SUBJECT: Historic Area Work Permit #633463, alterations to previously-enclosed side porch

**SUBJECT:** Revision to approved HAWP (HPC Case #35/13-13R) for alterations to previously enclosed side porch at 6 Quincy Street, Chevy Chase, a Contributing Resource within the Chevy Chase Village Historic District

**REVISED PROPOSAL:** The applicant is requesting HPC approval to change select window opening dimensions and extend the approved curvilinear bay feature by 1'6" beyond the approved curve depth. (See attached plans).

**Regan Residence**  
 6 Quincy Street  
 Chevy Chase, MD 20815

<b>Proposed Floor Plan</b>		<b>A1.0</b>
Project number	-----	
Date	11/8/2013	
Drawn by	JV	
Checked by	SSBR	Scale 1/4" = 1'-0"

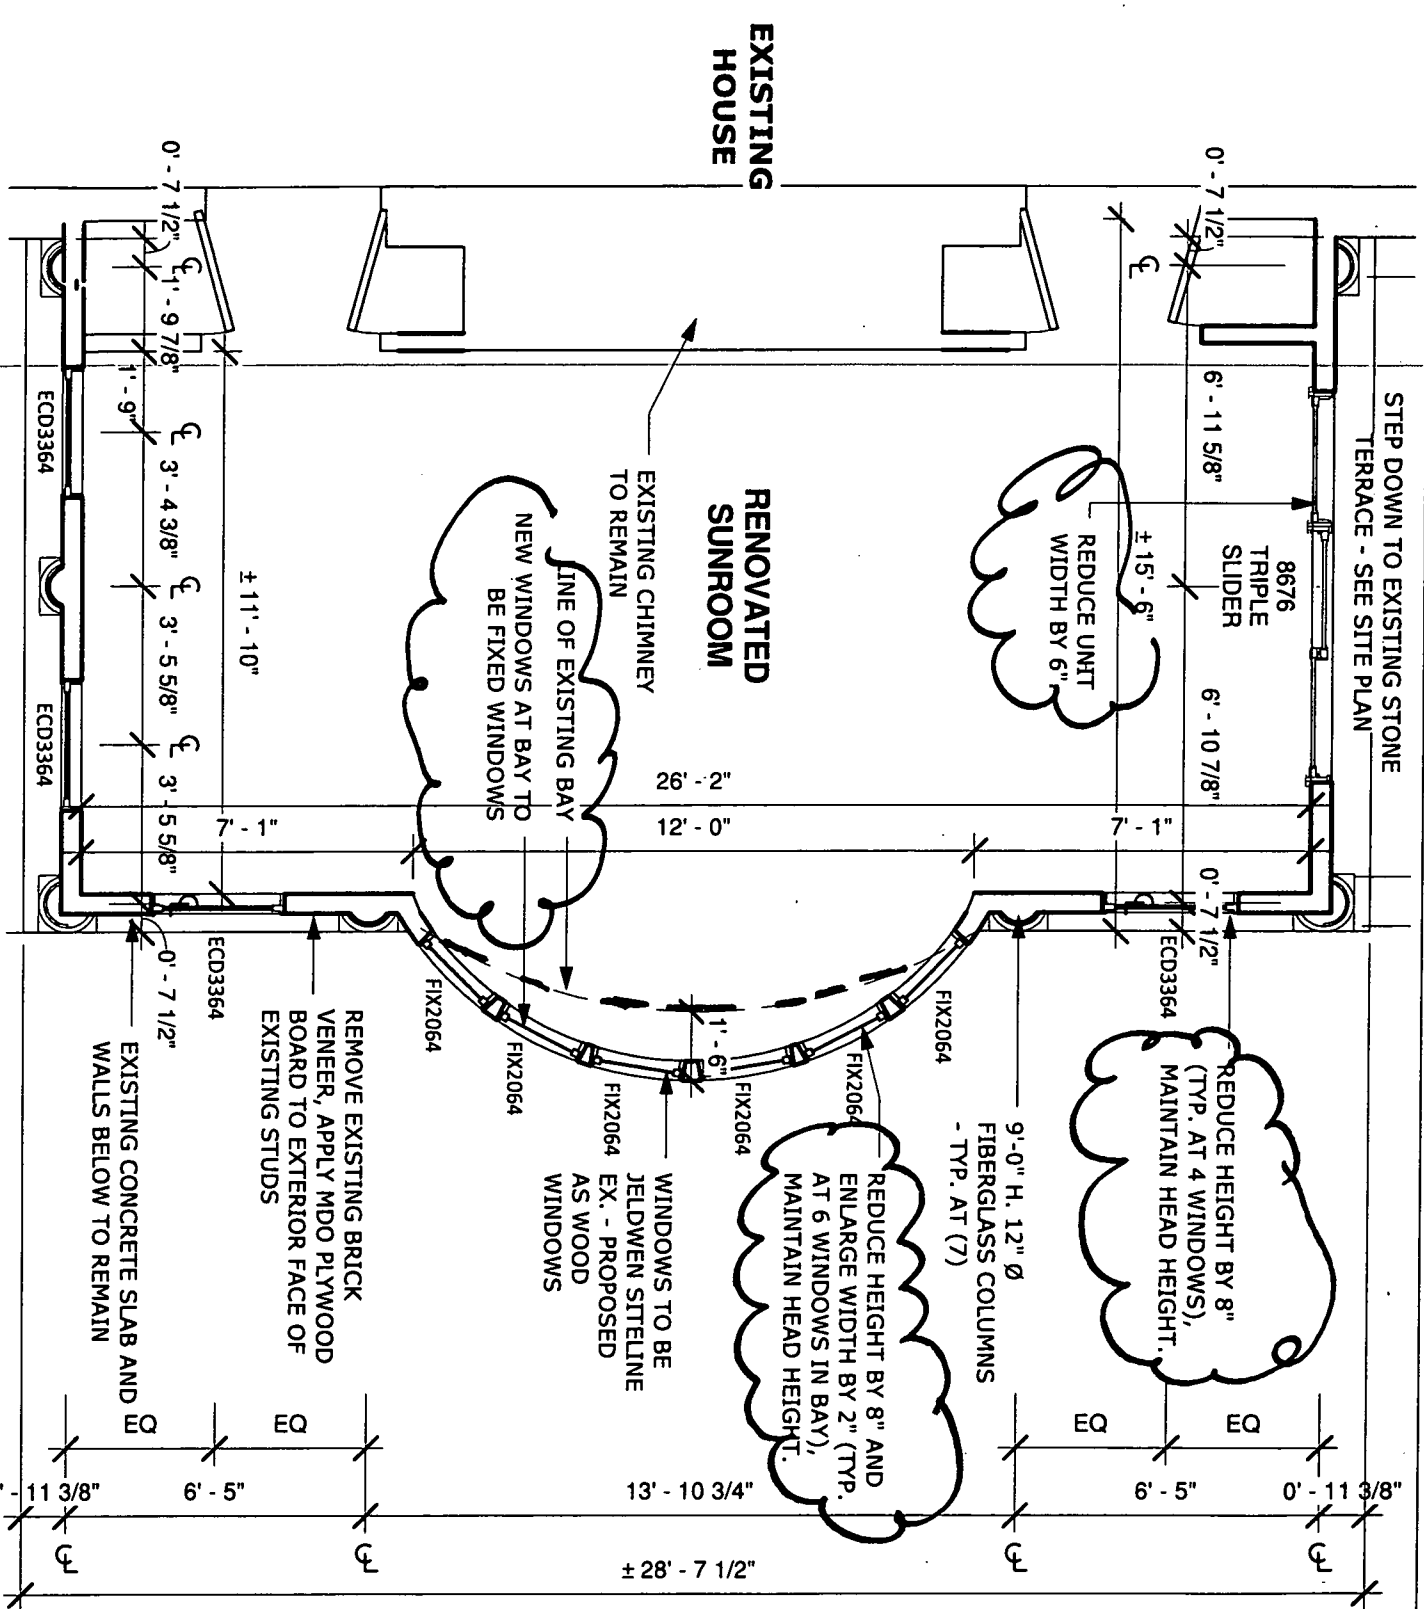
Please specify which window dimensions will be changed and by how much (8") on the revised plans and resubmit them to me via e-mail no later than COB, Monday, November 11<sup>th</sup>. Please include in the subject line of your e-mail when you resubmit the plans per my request above the word "Revision".

Attached please find the updated drawings per your request on October 28, 2013. For your convenience, I have attached the entire drawing package for the Regan residence at 6 Quincy Street, Chevy Chase (HAWP Case #35/13-13R), though the site plan and existing drawings have not changed. I updated the proposed floor plan and the three elevations with notes in red denoting the changes to the window sizes that we have proposed as requested.
